DATE: **July 10, 2023** FILE: **7921-0264-00**

RE: **Item B.16 of July 10, 2023 Regular Council – Land-Use Meeting**
Updated Tree Preservation and Tree Management Plans

Attachment – Updated Tree Preservation and Tree Management Plans

TREE REPLACEMENT PLAN

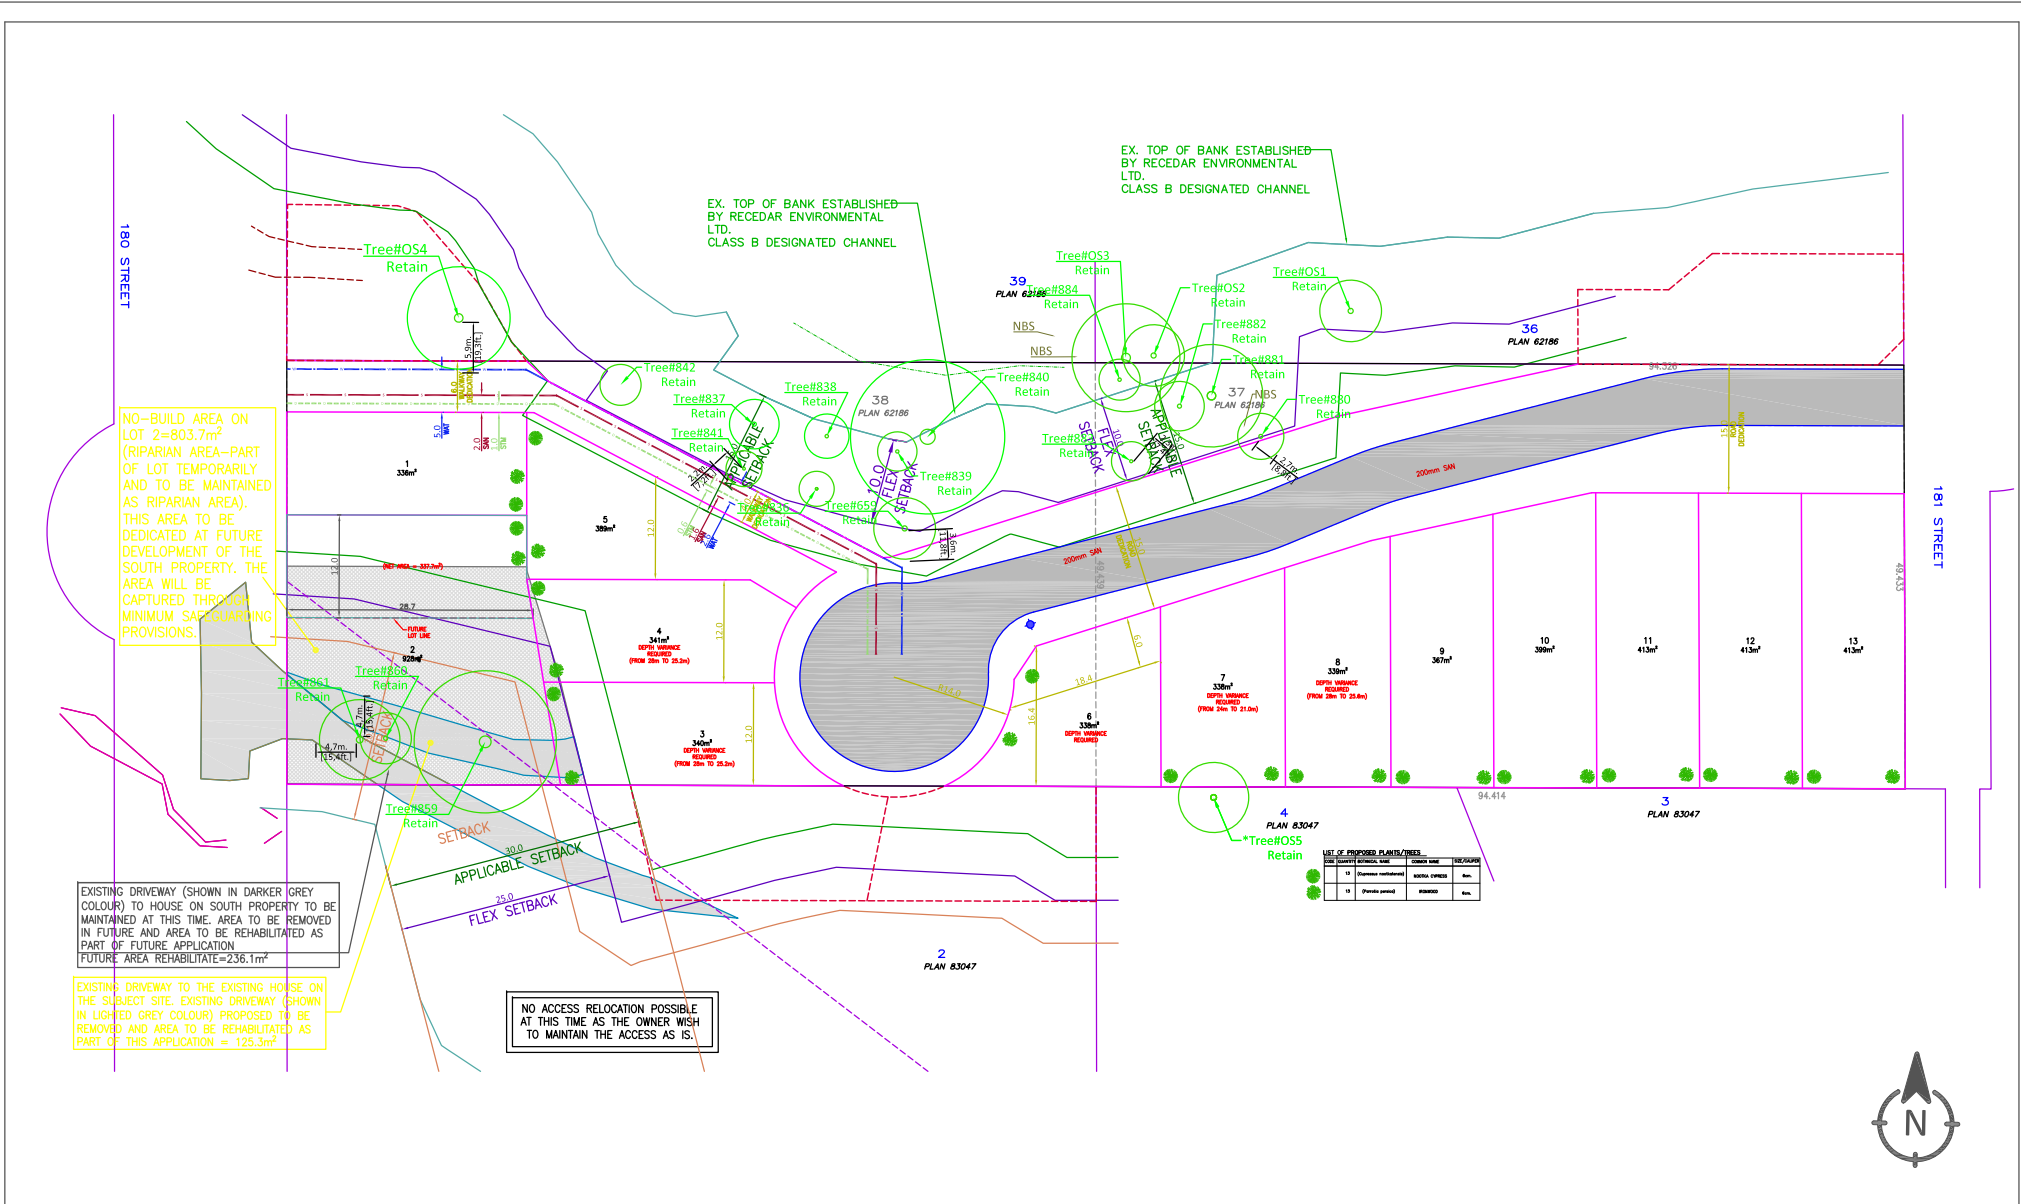
Appendix VI of the Planning & Development Report for Development Application No. 7921-0264-00 (Item B.16 of July 10, 2023 Regular Council – Land Use meeting) contains a ‘Summary of Tree Survey and Tree Preservation’, which also contains a Tree Preservation and Tree Management Plan. Staff have identified that the Tree Preservation and Tree Management plans currently appended to the report are based on a superseded lot layout.

Please see attached the updated Tree Preservation and Tree Management Plans with the correct lot layout for replacement into Appendix VI.

NO-BUILD AREA ON LOT 2=803.7m² (RIPARIAN AREA-PART OF LOT TEMPORARILY AND TO BE MAINTAINED AS RIPARIAN AREA). THIS AREA TO BE DEDICATED AT FUTURE DEVELOPMENT OF THE SOUTH PROPERTY. THE AREA WILL BE CAPTURED THROUGH MINIMUM SAFEGUARDING PROVISIONS.

EXISTING DRIVEWAY (SHOWN IN DARKER GREY COLOUR) TO HOUSE ON SOUTH PROPERTY TO BE MAINTAINED AT THIS TIME. AREA TO BE REMOVED IN FUTURE AND AREA TO BE REHABILITATED AS PART OF FUTURE APPLICATION. FUTURE AREA REHABILITATE=236.1m²

EXISTING DRIVEWAY TO THE EXISTING HOUSE ON THE SUBJECT SITE. EXISTING DRIVEWAY (SHOWN IN LIGHTER GREY COLOUR) PROPOSED TO BE REMOVED AND AREA TO BE REHABILITATED AS PART OF THIS APPLICATION = 125.3m²
